BROOKS LANDING – PHASE II PUBLIC IMPROVEMENTS
CITIZEN ADVISORY COMMITTEE MEETING MINUTES – MEETING #6
NOVEMBER 6, 2014 – 12:00 – 2:00 P.M.
GENESEE WATERWAYS CENTER

General plan of improvements – not all work is shown.

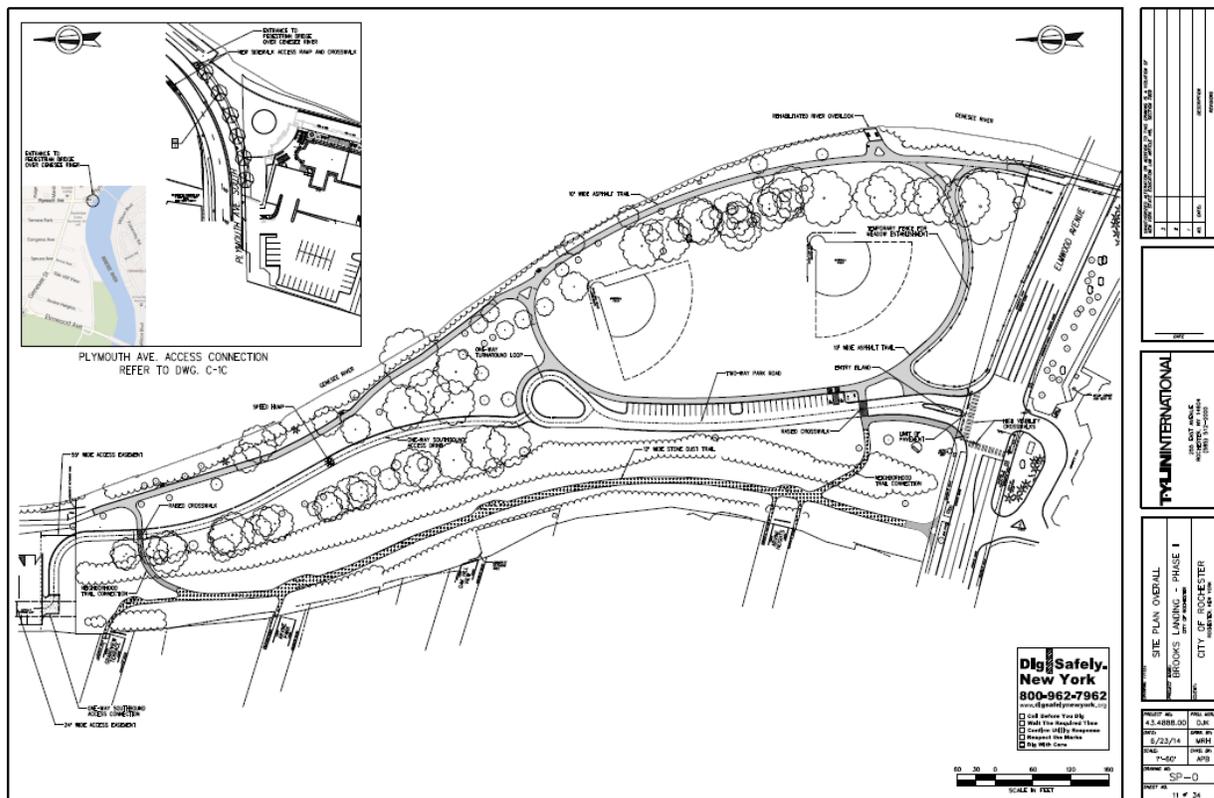
- After reviewing the planting plans there was concern that the plantings could contribute to an unsafe environment for park users.

- There should be sidewalks and lighting along the full length of the road. People will not use the trails to move thorough the park and they are unsafe.

All of the proposed planting are medium to large trees that will not obstruct visibility. The only exception being on the north end of the park where some lower and mid-size plants will be installed to screen views north to the hotel and tower.

The project does include selective clearing and removals of existing vegetation to improve visibility into and out of the park from Elmwood Avenue and the adjacent neighborhood.

The City noted that the plan presented at the last meeting did not include these elements as they were not requested previously. The City agreed to look at them in more detail after the meeting.

After consideration, these requests cannot be accommodated, for the following reasons:

- The project was advanced through final design based upon the plan presented at the previous meeting. The design has been reviewed and approved by all funding and oversight agencies.
- Accommodating these requests would require a complete re-design of the project as estimates for the work, as presented, use then entire available budget. Re-design would also require a new round of review and approval submittals to funding and oversight agencies.
- The remaining portion of Plymouth Avenue is no longer a City street, it is a park drive. According to City Code parks are only open dawn to dusk and closed at all other times. It is City standard practice not to light parks or trails/paths in parks, with few exceptions (highly programmed courts; trails adjacent to dense development).

- o Due to prior and current project funding, and agreements that helped create the development parcels, the State Office of Parks Recreation and Historic Preservation (OPRHP) had a significant oversight review of both projects. In response to the Environmental Assessment, OPRHP responded that they are supportive of the planned park improvements with the following stipulations:
 - Ensure enhancements to the park road meet industry MINIMUM standards for limited use.
 - Limit lighting (if any) along the road.

The City's interpretation of these stipulations would preclude the inclusion of the requested sidewalk and lighting. OPRHP is one of the agencies that has already approved the plans as presented.
